PLANNING, ZONING, & BUILDING DEPARTMENT  
PZ&B Staff Combination Memorandum: Architectural Commission and Town Council

SUBJECT: ZON-24-0046 (ARC-24-0090) 2720 – 2730 S OCEAN BLVD

MEETING: MAY 14, 2025

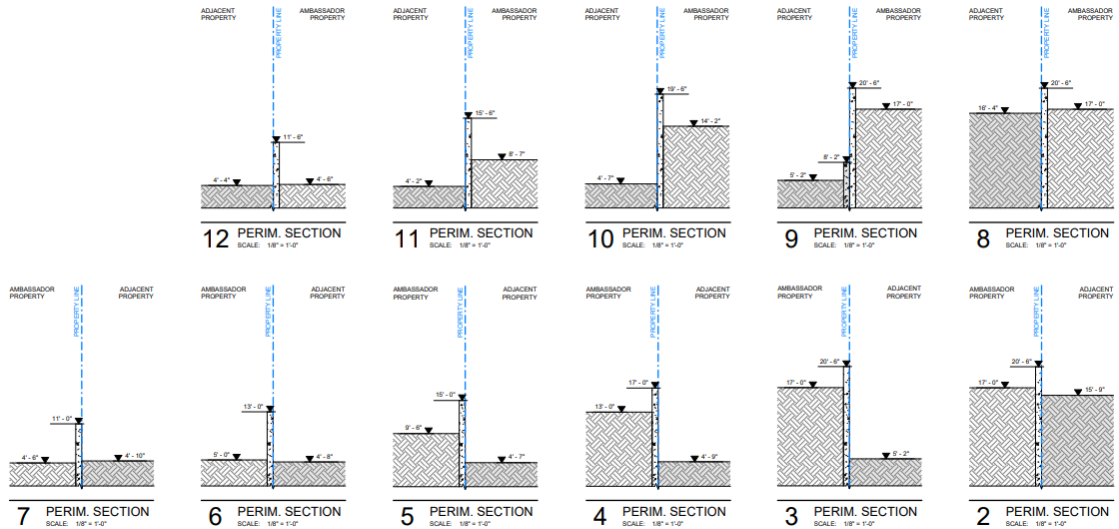
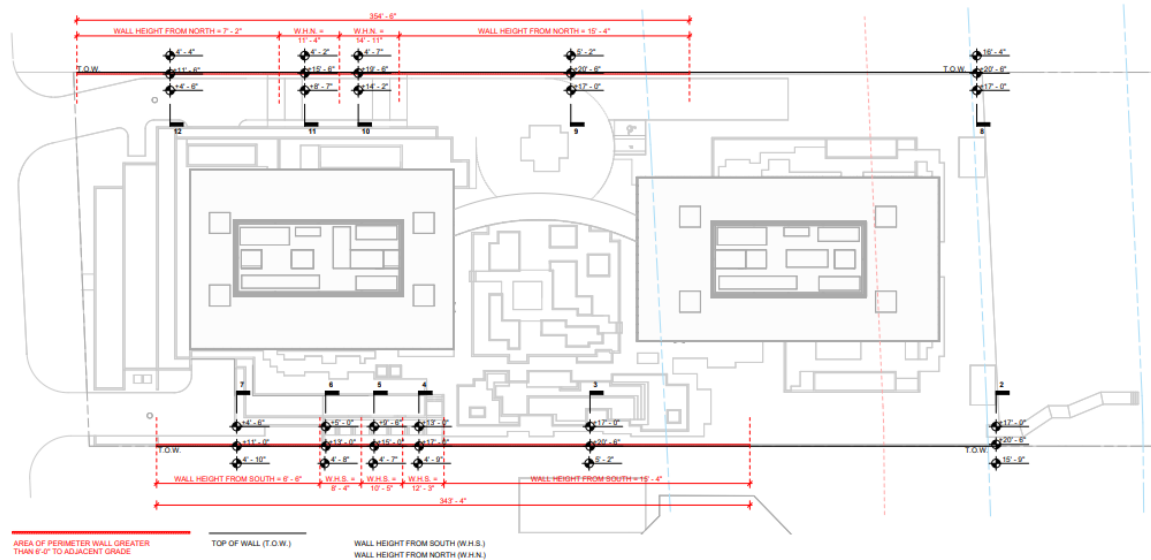
**Variance #21** variance to exceed by 1'-6" for 7'-2" the maximum height of walls, specifically perimeter walls, in front yard and 8'-6" for 15'-6" in side yards on the oceanfront Ambassador parcel. Walls located on these property lines must be measured from adjacent grade. Since the applicant is seeking to significantly raise the overall height of the parcel through adding fill to the sides and front and rear yards, the code maximum height does not work. The proposed variance request falls within both north and south property line walls as shown below:
